# PRODUCT FAULT INFORMATION

We have discovered incorrect information in technical documentation for Asymmetrical Horn antennas: **HG3-TP-A20-30, HG3-TP-A60, and HG3-TP-A90**

Step 4

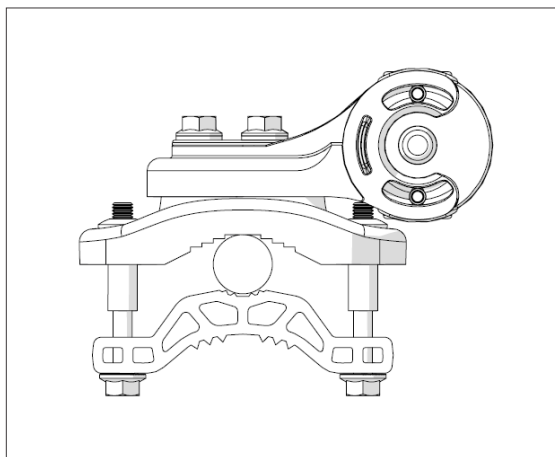
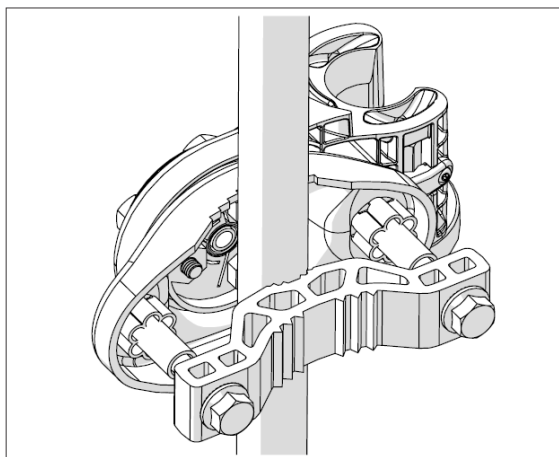
On page 7 of the user guide where Step 4 is described, a wrong lower limit of the pole diameter is listed. The top image showing the bracket installation indicates that the diameter of the pole can be 22 - 49 mm, as shown below.

**WRONG**

Place the AH-TP Bracket like this for pole diameter of **22** - 49mm

**The correct span of diameters is 36 - 49 mm.** Similar mistake has been identified and corrected in Product datasheets.

We advise you not using a pole with diameter smaller than 36 mm because of a risk of potential galling of the bolts which damages the bracket beyond repair. Our general recommendation is using the largest possible pole diameter within above mentioned correct span of diameters.
